CITY OF PORTLAND, MAINE
DEVELOPMENT REVIEW APPLICATION
PLANNING DEPARTMENT PROCESSING FORM
DRC Copy

2004-0080

Project Name/Description

RE: 219 Brackett Avenue, Peaks Island
(ID # 2004-0080, CBL #088M006)

SUBSURFACE WASTEWATER DISPOSAL PLAN

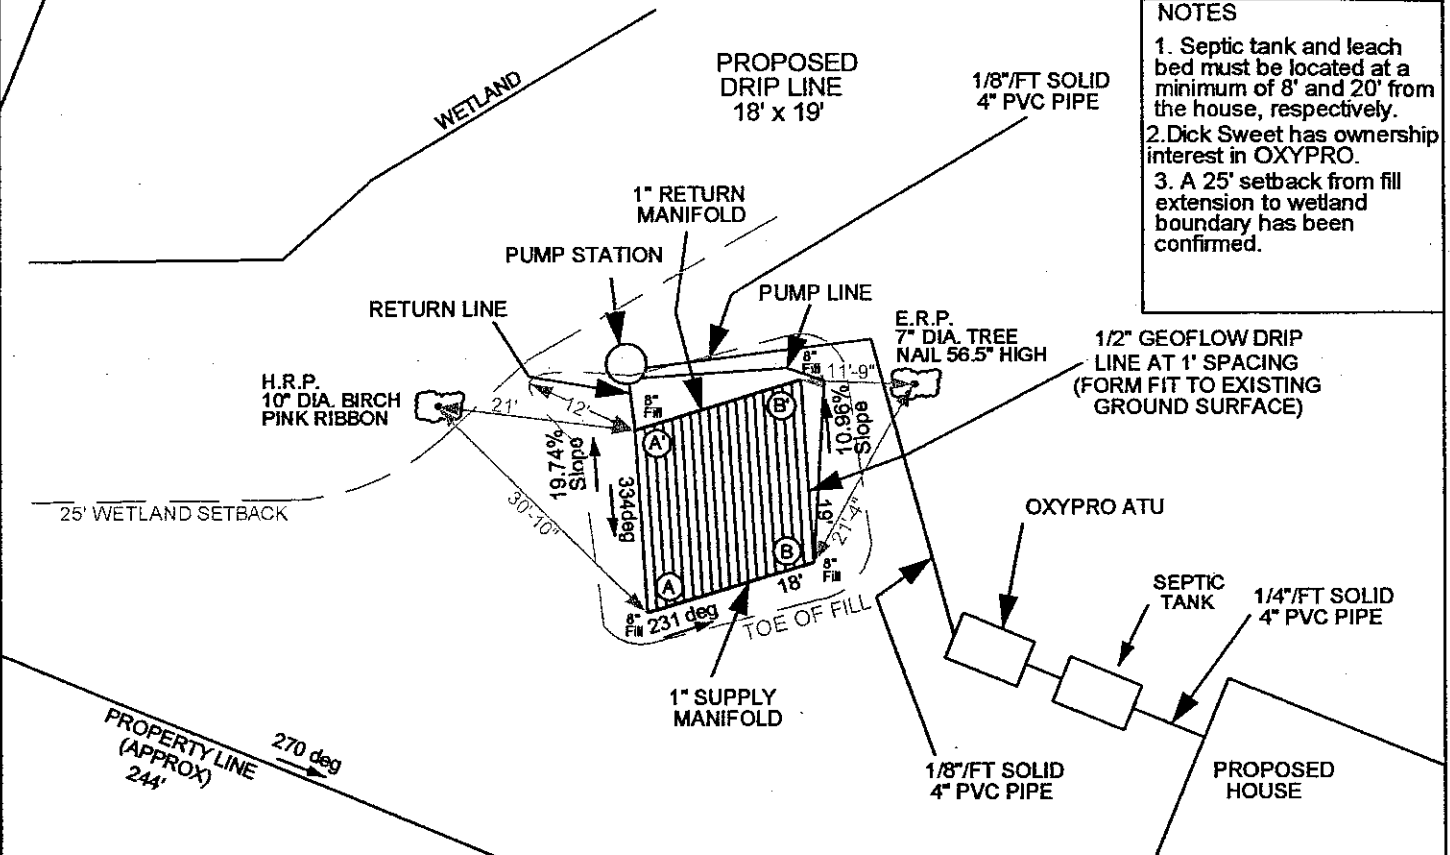
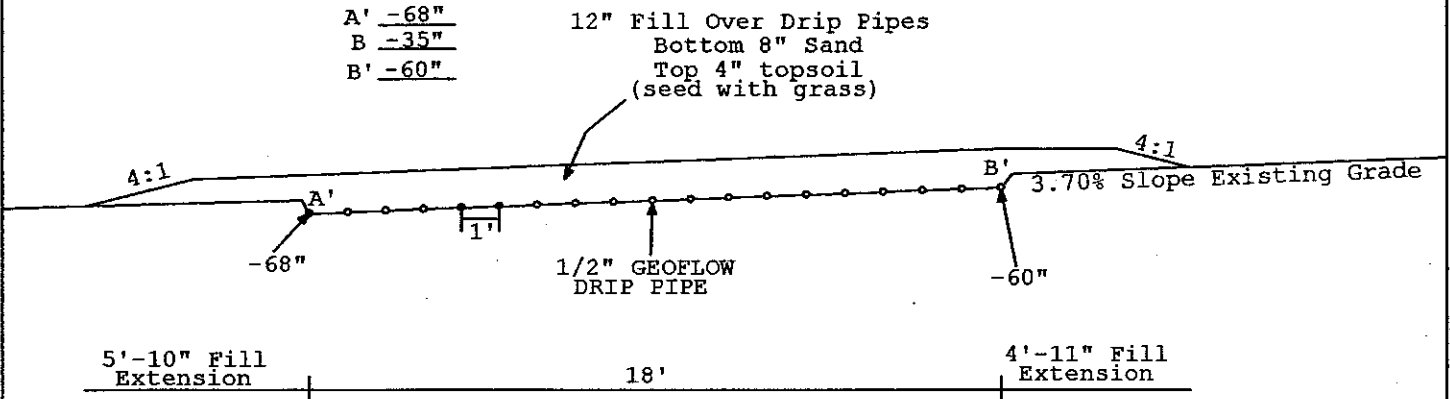
1. Wetlands have been flagged by Sweets Associates, who are Maine State certified geologists. These flags were then located on the survey prepared by SGC Engineering, LLC.
2. As a result of finding wetlands on the property, I am also submitting a redesign to the septic system, prepared by Sweets Associates. This proposal follows regulations set forth by the Maine Subsurface Waste Water Disposal Rules, 144A CMR 241.

- NOTES**
1. Septic tank and leach bed must be located at a minimum of 8' and 20' from the house, respectively.
 2. Dick Sweet has ownership interest in OXYPRO.
 3. A 25' setback from fill extension to wetland boundary has been confirmed.

PLOT PLAN
(revised)

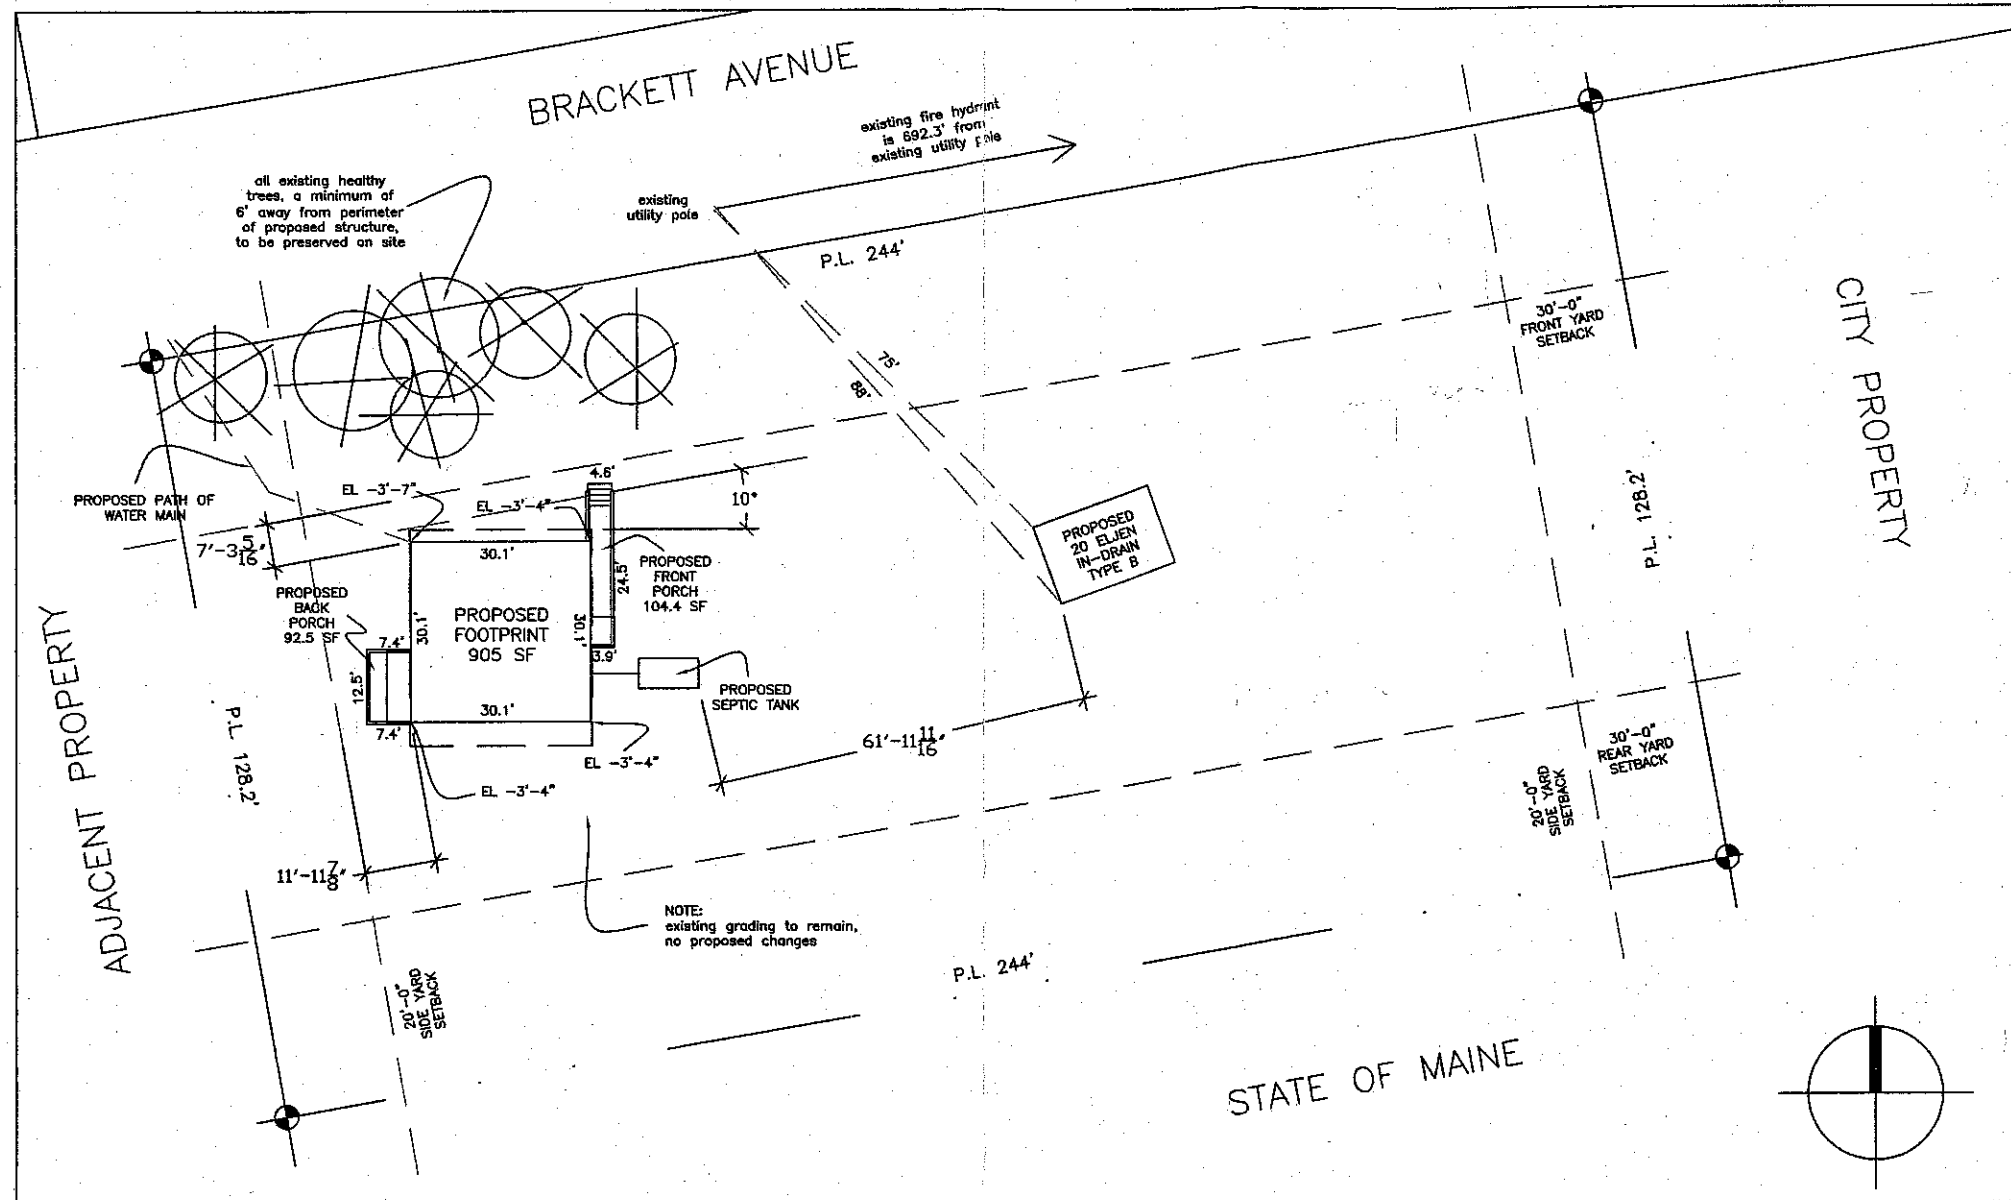
3. In SECTION 14-449 LAND USE STANDARDS, I found the requirement for a 75' setback from the up-land edge of a wetland. The proposed structure in the plot plan meets this requirement. However, the septic proposal does not. I have a couple of questions regarding this.

a. First, I can not find anything in the DIVISION 26. SHORELAND REGULATIONS which specifically addresses septic placement or guidelines, except for a note about soils testing for "proposed uses requiring

subsurface wastewater disposal...". Are there specific regulations regarding septic systems within the 250' Shoreland Zone, or is relocating its placement to meet the 75' setback sufficient to meet the requirements?

100' SB. to upland Edge.

b. Second, in DIVISION 25. SPACE AND BULK REGULATIONS AND EXCEPTIONS, SECTION 14-433. LOTS OF RECORD AND ACCESSORY STRUCTURE SETBACKS FOR EXISTING BUILDINGS, there is an exception for island residential zones which says "Any lot of record as of July 15, 1985, and held under separate and distinct ownership from adjacent lots and meeting the applicable street frontage requirements of that time may be considered a buildable lot in the IR-1 and IR-2 zones.....". I have a quitclaim deed which shows the deed of the prior owner dated November 30, 1971. Since the property falls under this exception, is the septic location o.k. as proposed?

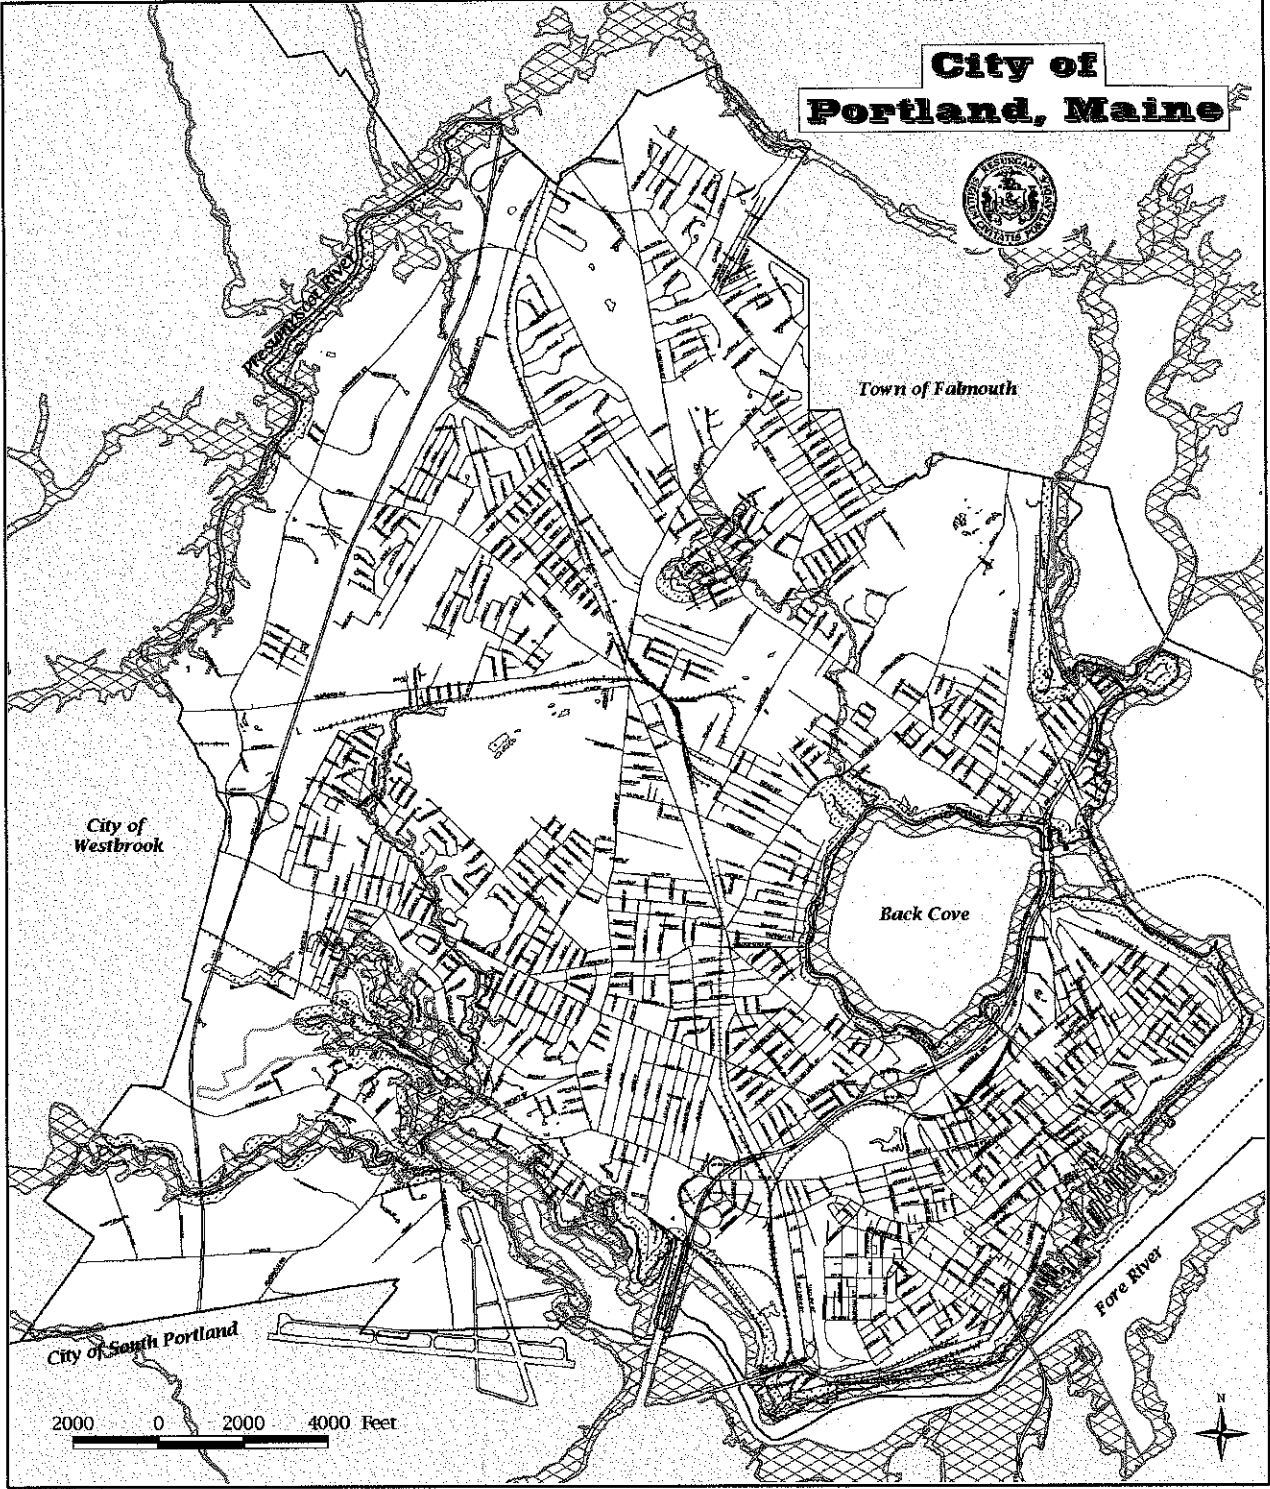
Thank you for your application for a single-family house at 225 Brackett Avenue. Upon review, planning department has the following comments:

1. Please add any/all proposed changes in grading. Also, add the sill or finish floor elevation.
2. Please add 2 proposed street trees along the ^{*Brackett*} ~~Island~~ Avenue frontage of the lot, as required by ordinance for single-family development. Saving existing healthy trees (as substitutes) is allowed by adding a tree preservation note to the plan.
3. Please show proposed utilities such as water, sewer and storm drain.
4. Please note the distance of the nearest fire hydrant on the site plan.
5. Please indicate any drainage courses, streams, and wetlands. Also, the City's zoning map indicates that there may be a resource protection zone in the vicinity of your lot. Please show this on your site plan.

Please find attached corrections made to the permit submission for a new single-family house to be located at 225 Brackett Avenue, Peaks Island. The following corrections have been made to the plot plan per your request:

- ✓ 1. I have added a note which states "existing grade to remain, no proposed changes". As well, I have included copies of the south, west, north and east elevations which show the finish floor elevation.

- ✓ 2. I have added trees and a note which states "all existing healthy trees, a minimum of 6' from the perimeter of the proposed structure, to be preserved on site".

- ✓ 3. I have added a dashed line which shows the path of the proposed water main, as well, I have drawn the proposed septic tank and 20 Eljen In-Drain Type B.

- ✓ 4. I have added the distance and direction of the nearest fire hydrant.
- ✓ 5. I have reviewed the City of Portland Resource Protection and Shoreland Overlay Zones and Floodplains Map. The only Resource Protection Zone I find on Peak's Island is in the location of the "ball field" which is approximately ½ mile away from the proposed site. Therefore, I did not note it on the plot plan. As well, there are no drainage courses, streams or wetlands on the property.

City of Portland Resource Protection and Shoreland Overlay Zones & Floodplains

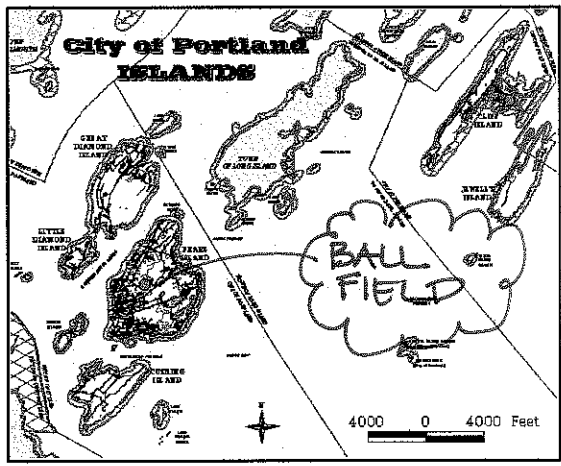
Attached is a jpg. of the official City Zoning map. It's not of great quality. The irregular shaped (ameoba) zone in the center of the map is the resource protection, and the dotted areas that surround it, is the shoreland zone (250' setback from upland edge).

My paper copy is better, you can see your lot and lot lines. This information may alter your building location. Please let me know if I can be of further assistance, and I look forward to your response.

1. I need a little help interpreting the "NOTE" as written on "Zoning Map". It reads:

"The depiction of the shoreland zones districts and stream protection districts are illustrative of the general location of such zones. The actual boundaries of these zones shall be determined by measurement of the distance indicated on the map from the normal high water line of the water body of the up-land edge of wetland vegetation. Where such measurement is not the same as the location of the boundary on the zoning map, the measurement shall control, unless the zoning map indicates that the zone boundary shall follow an existing property line."

Could you clarify what this means about determining the "actual boundaries of these zones". If the map is showing "general locations", what does it mean to determine the "actual boundary" by measuring the "distance indicated on the map"? Is it simply saying that the dotted area might not actually measure 250' and if you scale it with a ruler and find the measurement to be less than 250', then you can use that measurement? (Mostly I am curious, I do not think that this will effect the project.)

2. I made a trip to the site and found the southeastern corner to show the only clear sign of water. There are no notable streams, only run off from roads. It seems clear that the water must be due to a wetland condition. Is it necessary to hire an engineer to officially designate this small corner as a wetland, or can I simply state it as such?
